ADDENDUM No.3

HERITAGE HIGH SCHOOL

CITY OF LYNCHBURG BID NO.: 14-896
LYNCHBURG CITY SCHOOLS C.I.P. NO.: YS032
3020 WARDS FERRY ROAD
LYNCHBURG, VIRGINIA 24502

FEBRUARY 28, 2014

DRAWING TITLE:	CONTRACT DWG NO.:	PROJECT:	DRAWN BY:	ATTACHMENT TO:	SUPPLEMENTAL DWG. NO:
REVISIONS TO PART J COMM	E2.9.3	HERITAGE HIGH SCHOOL 3020 WARDS FERRY ROAD, LYNCHBURG, VA 24502	JAT	AD3	AD3-
			DATE: 02/28/14	PROJECT NO: 520910	E2.9.3-1

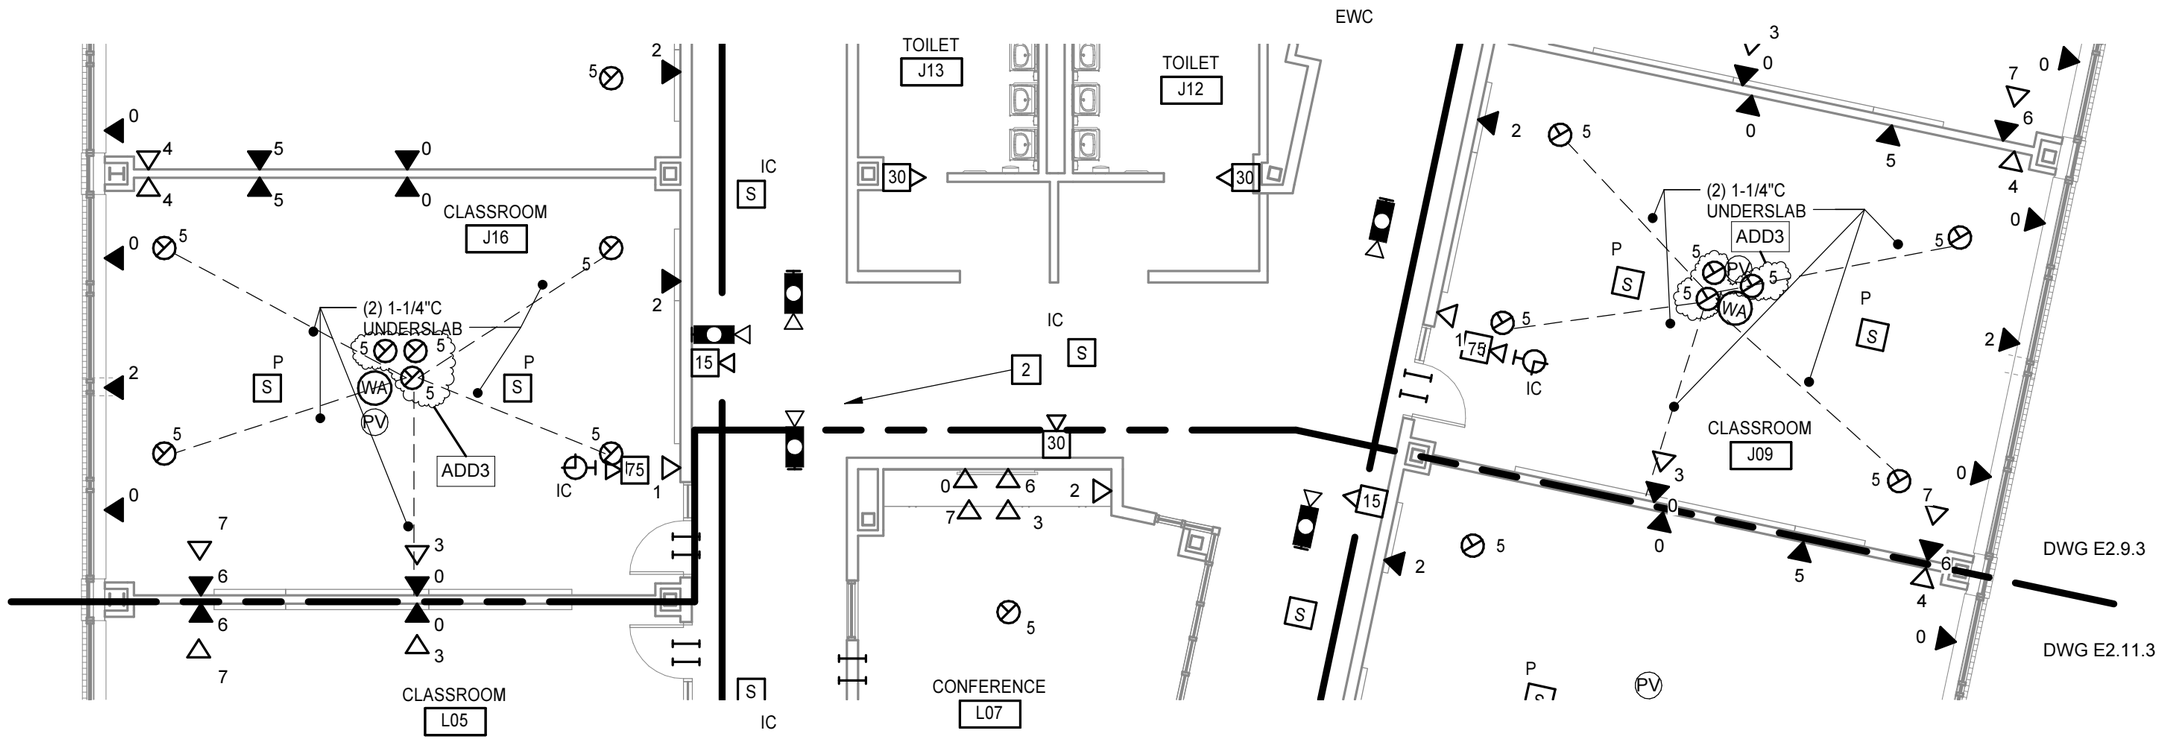
DRAWING E2.9.3:

1. Revise Part J Comm Classroom J09 and J16 per sketch AD3-E2.9.3-1.

DRAWING TITLE:	CONTRACT DWG NO.:	PROJECT:
REVISION TO FIELD HOUSE RISER	**E1.4**	**HERITAGE HIGH SCHOOL** **3020 WARDS FERRY ROAD, LYNCHBURG, VA 24502**

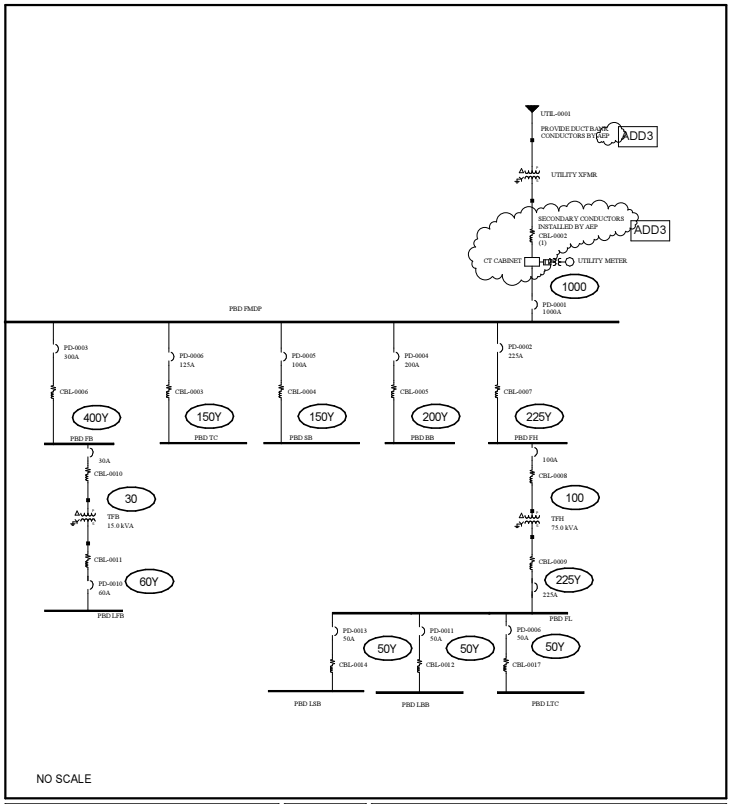
DRAWING E1.4:

1. Revise Field House Riser Diagram per sketch AD3-E1.4-1.
